# St Clement: Safe Routes to School

## Public Consultation Report

12 May 2017

## 1. RUE DE MAUPERTUIS BENDS ISSUES:

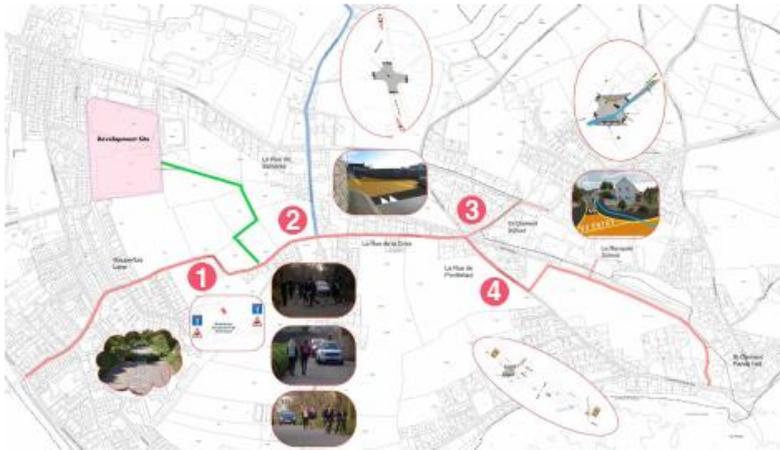
When making this lane no entry to cars maybe some kind of other barrier rather than planters as I bet the motorcycles and mopeds will still go down there as a short cut regardless of the no entry signs.

One suggestion I would have is on the plan item "1" (Rue du Maupertuis bends) it shows 1 x planter in place to prevent through traffic. I would politely suggest that 3 x planters be used, placed in a tight "chicane" format, as to place one would still allow fast motorcycles to have access at speed. (the main culprits and danger threat as I would see it currently.) This tight "chicane" format would still allow walkers and cyclists ease of access but would prevent the motorcyclists from doing so at speed. This could be placed at the south of the opposite field entrances to allow the farmer access to the fields. (the same position as when they were placed when the road was closed during repair work to the sewage water pipes a few years back.)

## 3. RUE DU PONTLIETAUT - RAISED TABLE

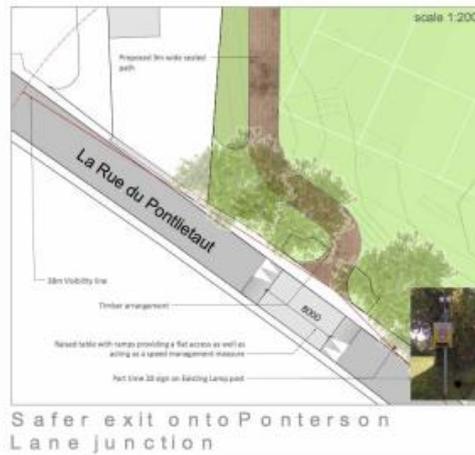
### 3. Rue de Pontlietaut Raised table

As stated above, there is no evidence that a raised table reduces speed. It increases environmental pollution in an area with lots of schools.

Again, why can't you put a zebra crossing here? This will alert drivers to the likelihood of pedestrians crossing. The visual splay at this junction is already very good indeed. Also, you need to put double yellow lines as we get parents parking on the northern sector of Rue de la Croix which means if you are trying to turn right into Rue de la Croix from Rue de Pontlietaut you have to swing very wide to access the lane.

What evidence is there of threat to the children at this junction. Has anyone actually been injured?
